# Access Compliance Report

## Public Rights-of-Way

Intersection ID: 13450	Main Street: S_MCDOWELL_ST	Cross Street: E_MARTIN_LUTHER_KING_JR_BV	Location: N
ADA ID: BB263007802B	Ramp Type: PerpDiag	Initial Pass/Fail: Fail	Overall Compliance: No
		Severity Score: 10

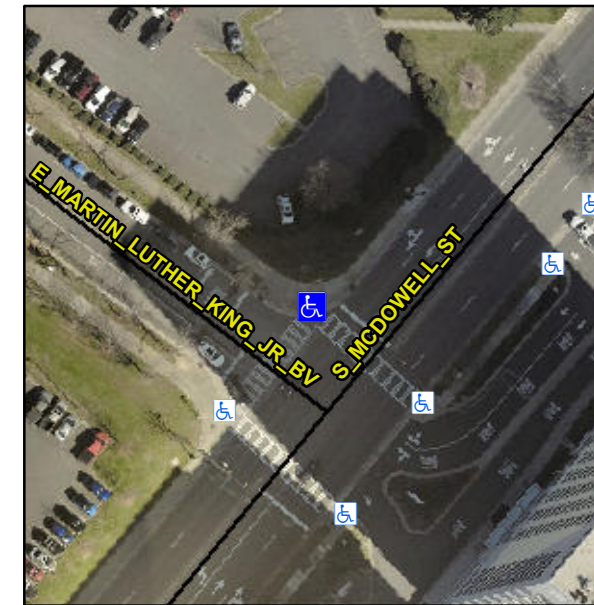
**Not Found, R304.5.1, R304.5.3**

Compliance	Description	Data	Compliance	Description	Data
N/A	Ramp Length (in)	88.0	Yes	Ramp Slope (%)	6.3
No	Ramp Width (in)	36.0	No	Ramp XSlope (%)	2.4
N/A	Flare Type LT	N/A	N/A	Flare Type RT	N/A
N/A	Flare Slope LT (%)	N/A	N/A	Flare Slope RT (%)	N/A
N/A	Flare Traversable LT?	N/A	N/A	Flare Traversable RT?	N/A
N/A	Landing Length (in)	N/A	N/A	DWS Provided?	N/A
N/A	Landing Width (in)	N/A	N/A	DWS Contrast?	N/A
N/A	Landing Slope (%)	N/A	N/A	DWS Length (in)	N/A
N/A	Landing X Slope (%)	N/A	N/A	DWS Full Width?	N/A
N/A	Landing Curb? (Y/N)	N/A	N/A	DWS Offset (in)	N/A
N/A	Shared Landing?	N/A			
N/A	Gutter Ponding?	N/A	N/A	Gutter Slope (%)	N/A
N/A	Gutter Lip Ht (in)	N/A	N/A	Gutter X Slope (%)	N/A
N/A	Painted X Walk1?	Yes	N/A	Painted X Walk2?	Yes
	X Walk 1 Direction	To SW		X Walk 2 Direction	To SE
N/A	X Walk 1 Width (in)	118.0	N/A	X Walk 2 Width (in)	112.0
	X Walk 1 Slope (%)	0.8		X Walk 2 Slope (%)	0.2
	X Walk 1 X Slope (%)	1.0		X Walk 2 X Slope (%)	2.0

**Remove & Replace Curb Ramp With Two New Directional Ramps or Equivalent.**
